ALERT SERVICE BULLETIN

ASB NO. 94045 REV. D • DATE: DECEMBER 20 1995 • PAGE 1 OF 11

SUBJECT: **CROSSTUBE ASSEMBLY;**
P/N 206-321-001 and -002 (High Skid
and Lightweight Float Crosstubes),
P/N 206-320-101 and -102 (Low Skid
Crosstubes), and P/N 206-329-001 and
-002 (Pan Style Float Crosstubes),
INSPECTION AND OR MODIFICATION OF.

HELICOPTERS AFFECTED: All Bell 206A and 206B model
helicopters equipped with subject
crosstubes.

FIGURE 1

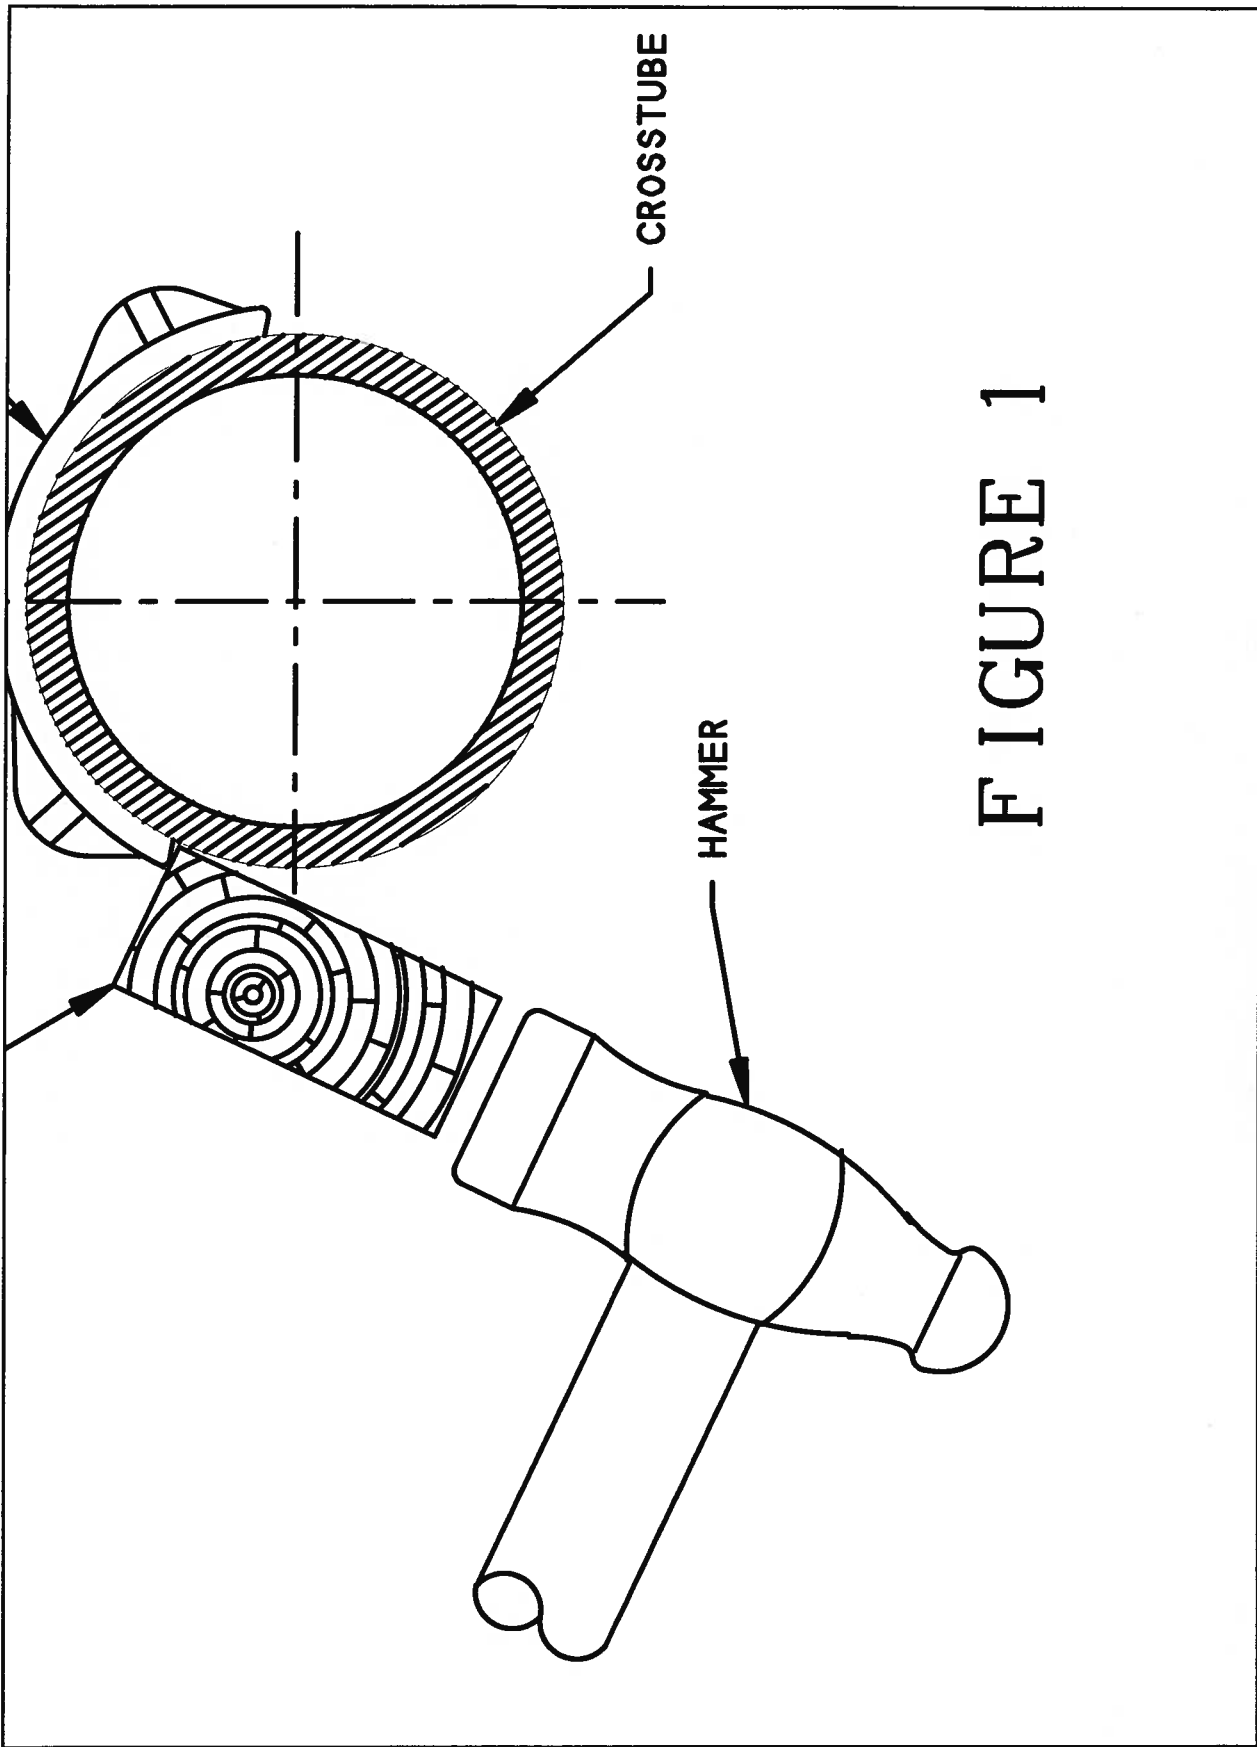
7. Use a Heat Gun to heat the Support/Sealant and remove the Clamp-On-Support. If necessary use a block of wood and hammer to strike the Support abutment in an upward motion to remove Support as shown in Figure 1. CAUTION: Support could be hot!
8. Remove remaining sealant and clean with isopropyl alcohol.

FIGURE 2

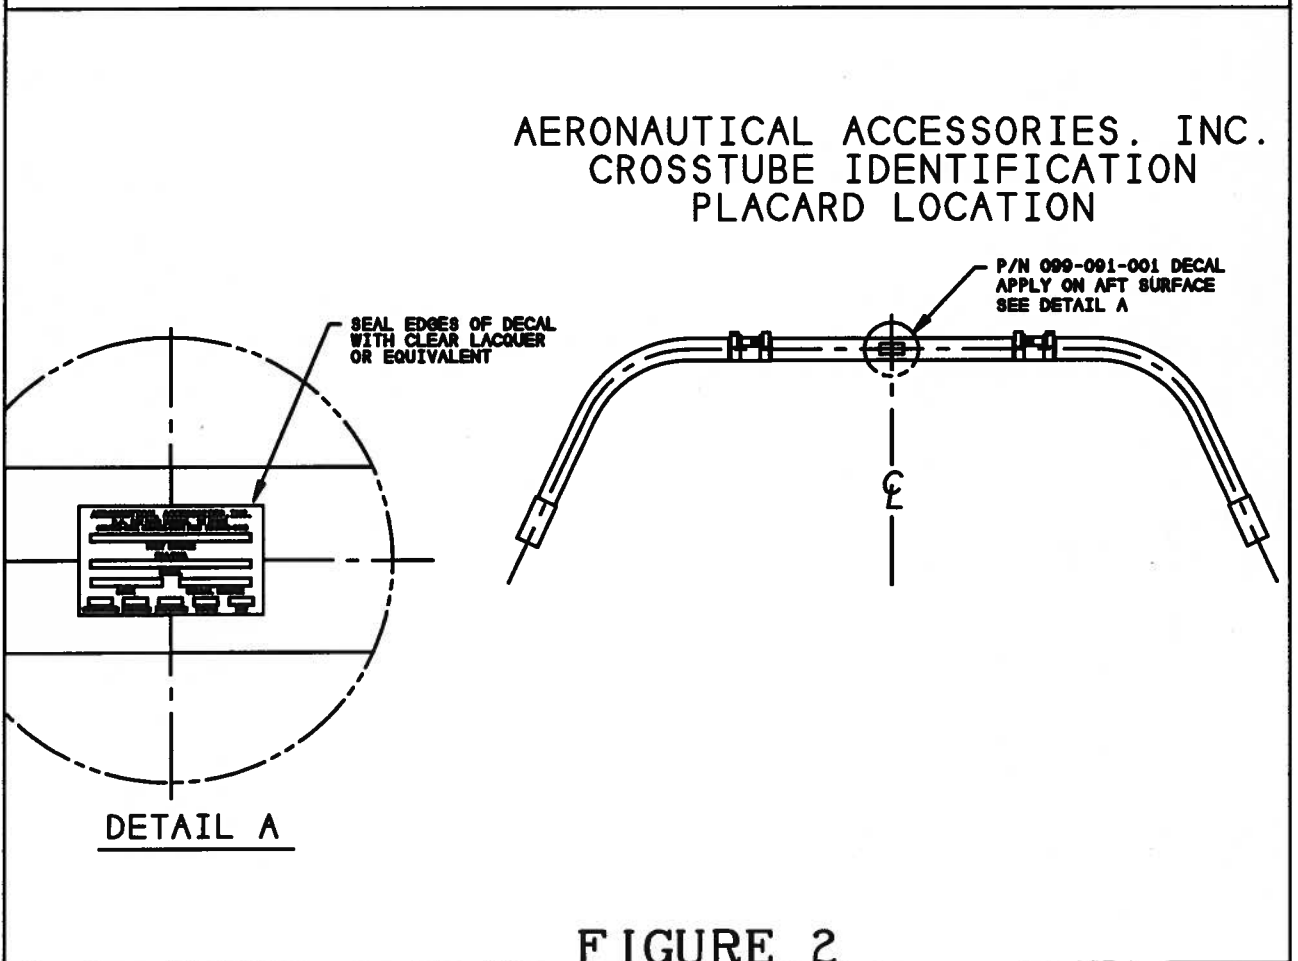
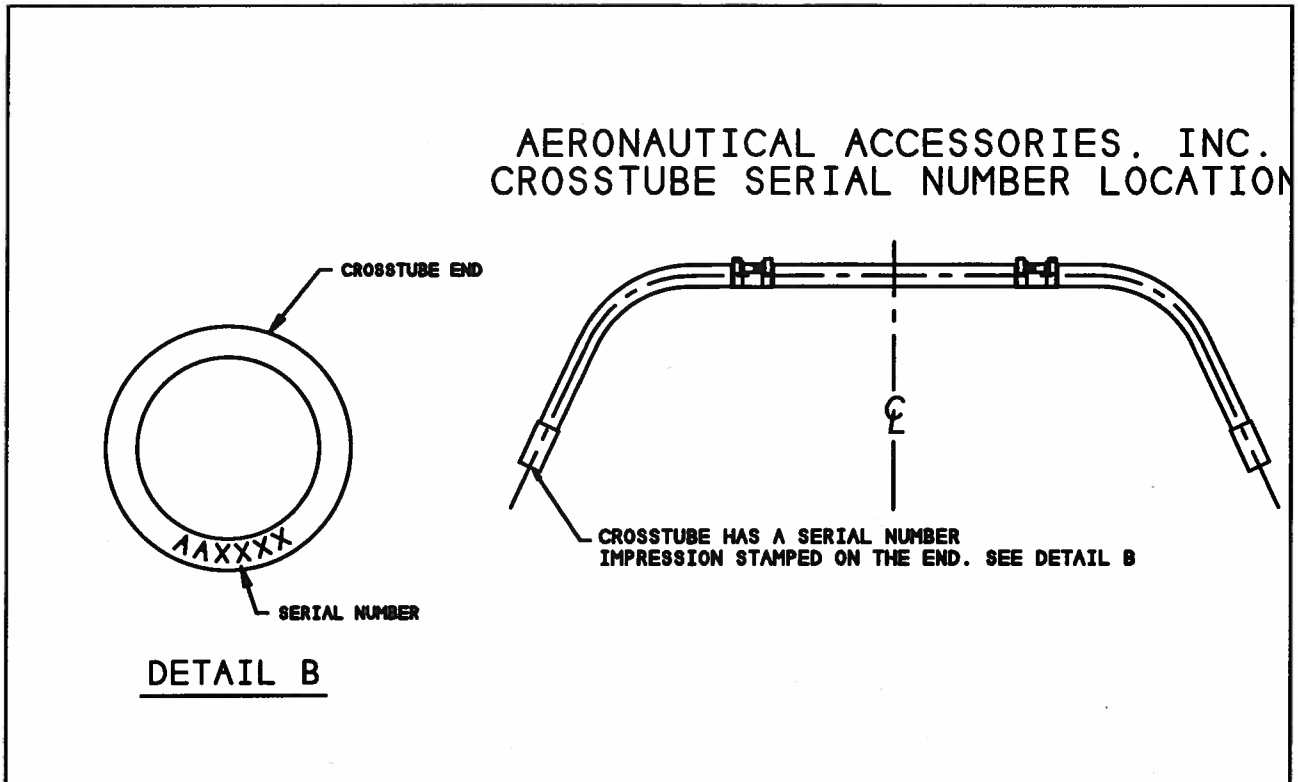
8. Use a Heat Gun to heat the Support/Sealant. If necessary use a block of wood and hammer to strike the abutment of Support in an upward motion to remove Support as shown in Figure 2. **CAUTION** Support could be hot!
